ADDRESS: 10501 PUDDING LANE  
ELLCOTT CITY, MD 21042

PLOT PLAN  
LOT 36  
**KINGS FOREST**  
LIBER 20039, FOLIO 212  
PLAT NO. 25766  
2ND ELECTION DISTRICT  
HOWARD COUNTY, MARYLAND

# FILE INQUIRY NOTES

SCALE  
1" = 30'

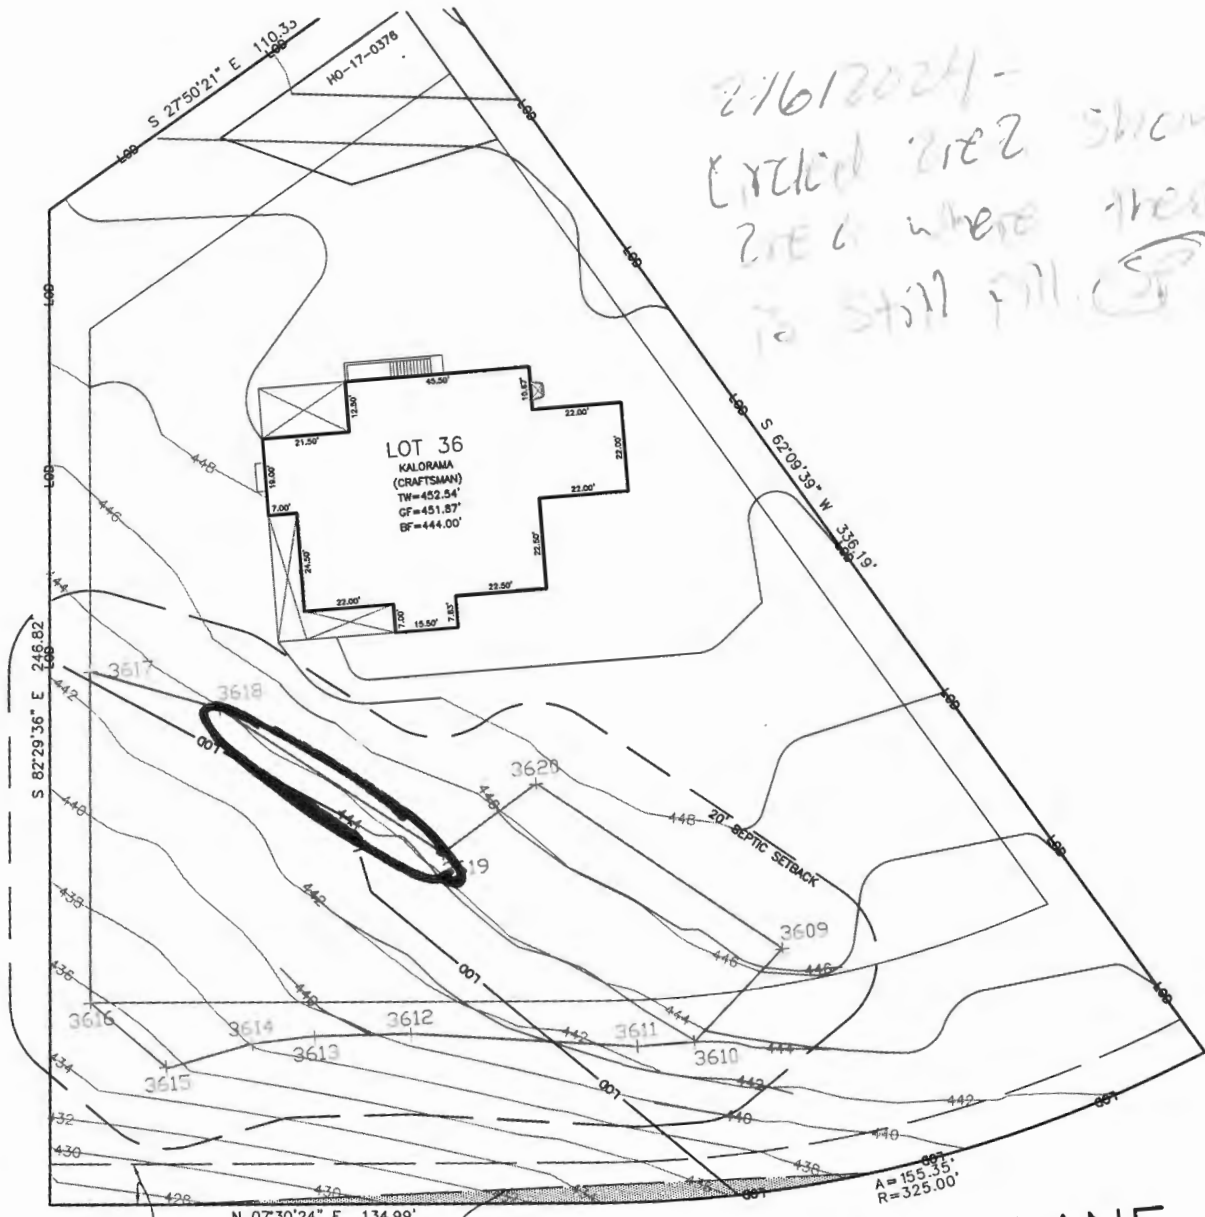
DATE	RESULTS OF REVIEW FOR FILE
1/23/24	- site inspection, equipment still onsite moving dirt & digging the house
	foundation. SDA stakes were in place, appeared that the stakes closest
	to the house were disturbed - the big spoil pile is right next to them.
	There a large pile of rock covered w/ snow right in the middle of the
	SDA. Snow fencing was partially down. (see pic) - see pic

2/16/2024 -  
EXCLUDED TREE SHOWS  
TREE WHERE THERE  
IS STILL FILL.
